Access Compliance Report

Public Rights-of-Way

Intersection ID: 46360	Main Street: GARDNER_LN	Cross Street: GARDNER_POND_CT	Location: NE
ADA ID: 3B9752FE7175	Ramp Type: Perp	Initial Pass/Fail: Fail	Overall Compliance: No
			Severity Score: 26.25

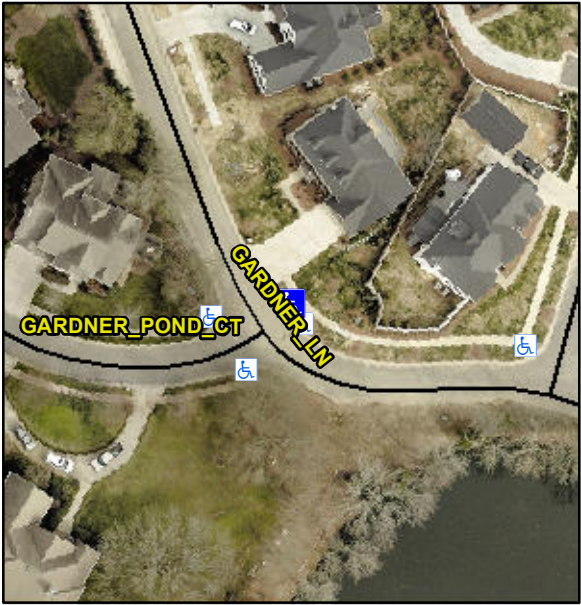
Codes/Mitigation Info/Possible Solution		Field Measurements/Component Compliance					
 <p>Street 1 Name GARDNER POND LN</p> <p>Stop Condition-Street 2 None</p> <p>Street 2 Name N/A</p> <p>Stop Condition-Street 1 N/A</p>	<p>Possible Solutions:</p> <p>Remove & Replace Entire Ramp.</p> <p>Surveyor Notes:</p> <p>N/A</p> <p>PROW/ADA:</p> <p>R304.2.2</p>	<p>Compliance</p> <p>Description</p> <p>Data</p>	<p>Compliance</p> <p>Description</p> <p>Data</p>				
		N/A	Ramp Length (in)	96.0	No	Ramp Slope (%)	12.1
		Yes	Ramp Width (in)	48.0	Yes	Ramp XSlope (%)	3.5
		N/A	Flare Type LT	N/A	N/A	Flare Type RT	N/A
		N/A	Flare Slope LT (%)	N/A	N/A	Flare Slope RT (%)	N/A
		N/A	Flare Traversable LT?	N/A	N/A	Flare Traversable RT?	N/A
		N/A	Landing Length (in)	N/A	N/A	DWS Provided?	N/A
		N/A	Landing Width (in)	N/A	N/A	DWS Contrast?	N/A
		N/A	Landing Slope (%)	N/A	N/A	DWS Length (in)	N/A
		N/A	Landing X Slope (%)	N/A	N/A	DWS Full Width?	N/A
